A SESSION OF THE CITY OF HUXLEY'S PLANNING AND ZONING COMMISSION

HUXLEY, IOWA
INNOVATIVE TECHNOLOGIES SITE
SITE PLAN

RE: Innovative Technologies Site 1545 Blue Sky Boulevard Internal City Comments Response Huxley, Iowa

RE: Innovative Technologies Site 1545 Blue Sky Boulevard Site Plan Review Huxley, Iowa

STORM WATER POLLUTION

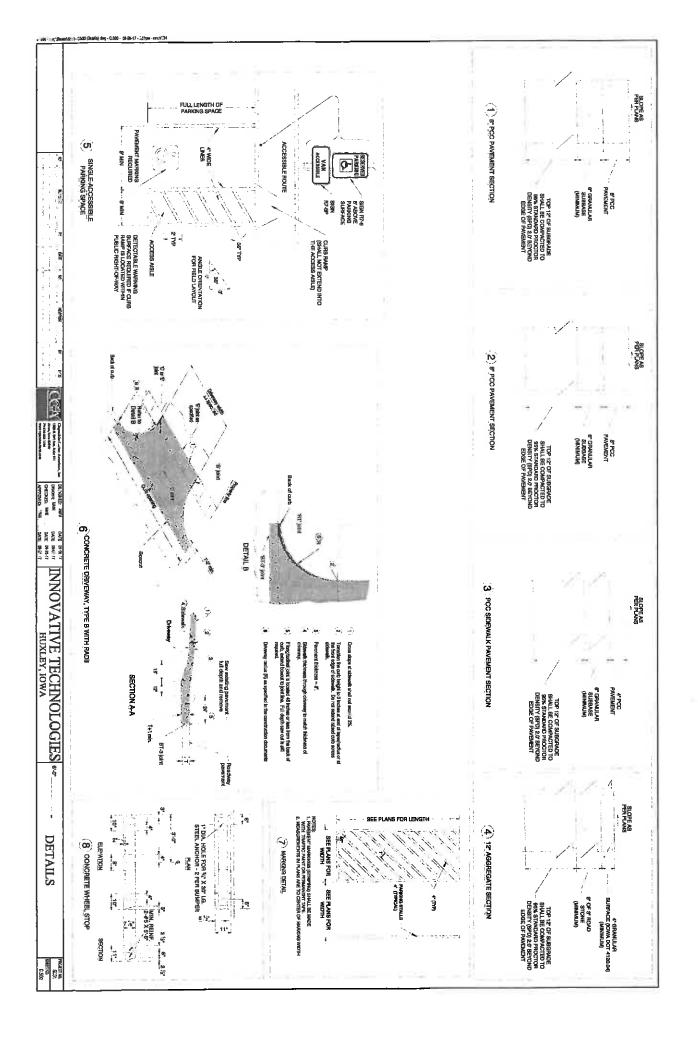
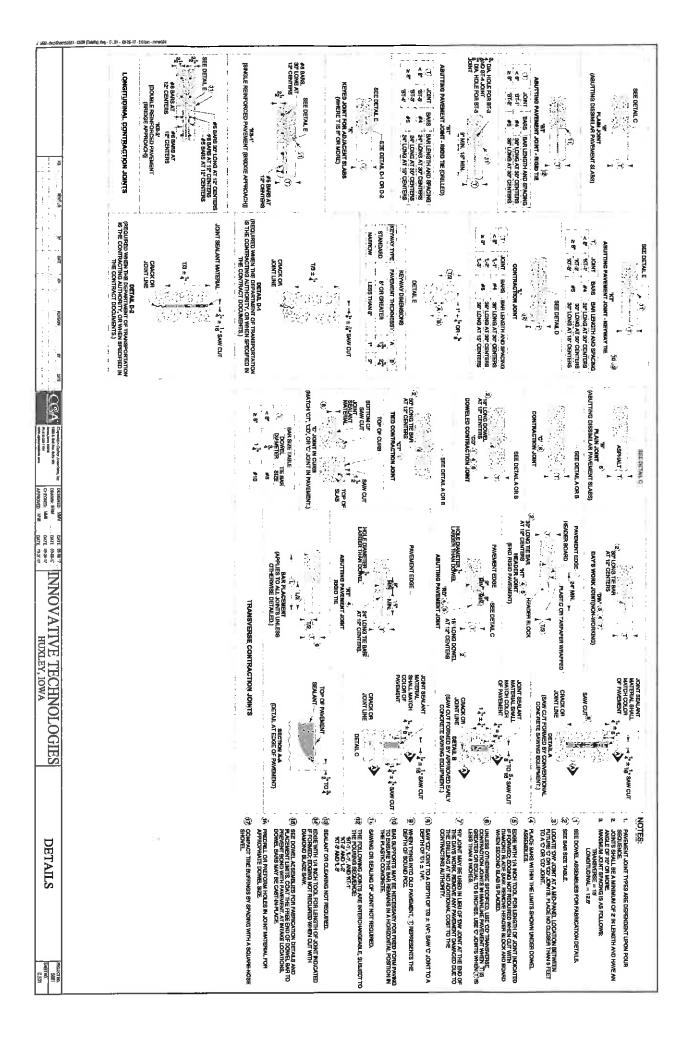
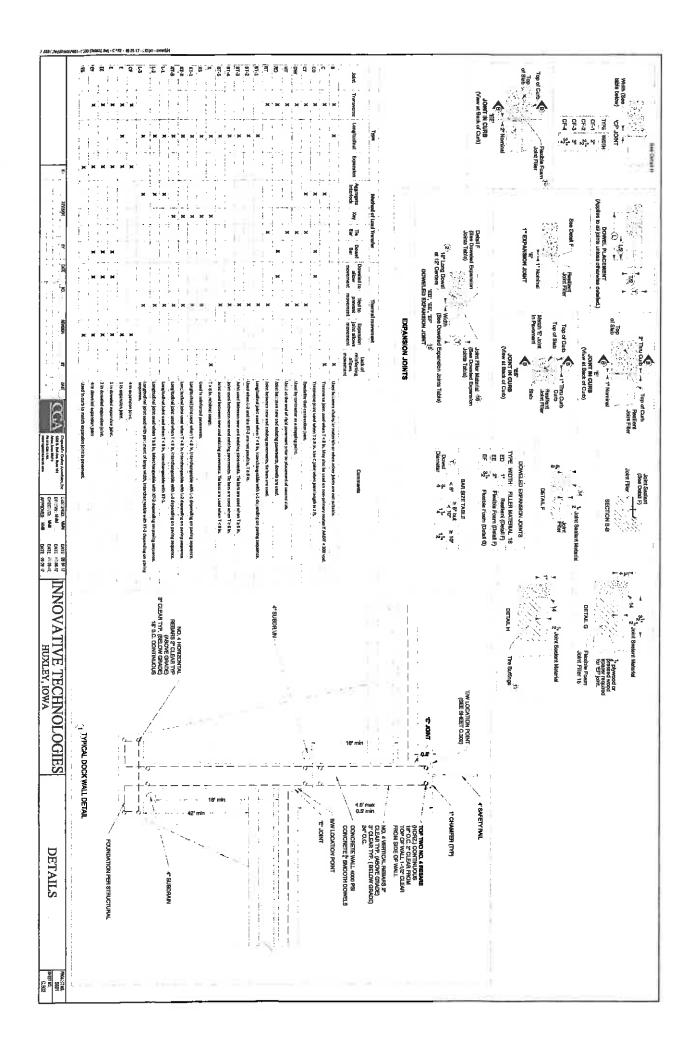
1. Comments: The SUDAS Design Standards, section 2G-1, Par. F.1 requires a minimum detention basin bottom cross slope of 2%. The proposed basin has a flat bottom. Please provide a sloped bottom at a minimum of 2% slope or provide a concrete paved swale or channel bottom cunette and subsurface drains. The detention pond volume will need to be recalculated to verify adequate storage is still provided.

2. Comments: The same SUDAS Design Standards paragraph requires a 1-foot of freeboard above the emergency spillway discharge or 2 feet of freeboard above the 100 year surface elevation. The proposed freeboard is approximately 3 inches. Please provide 2 feet of freeboard or an emergency spillway with 1 feet of freeboard.

Response: Please see updated plan set and storm water report. The detention basin was adjusted to have a minimum of 2% slope towards the CMP outlet pipe.

Response: Please see updated plan set. The detention basin has a 100 year surface elevation of 983.93 and top of basin elevation of 985. There is an emergency spillway to the outlet of the CMP pipe on the southwest of the site for storms larger than the 1-foot freeboard. Building FFE is 990.
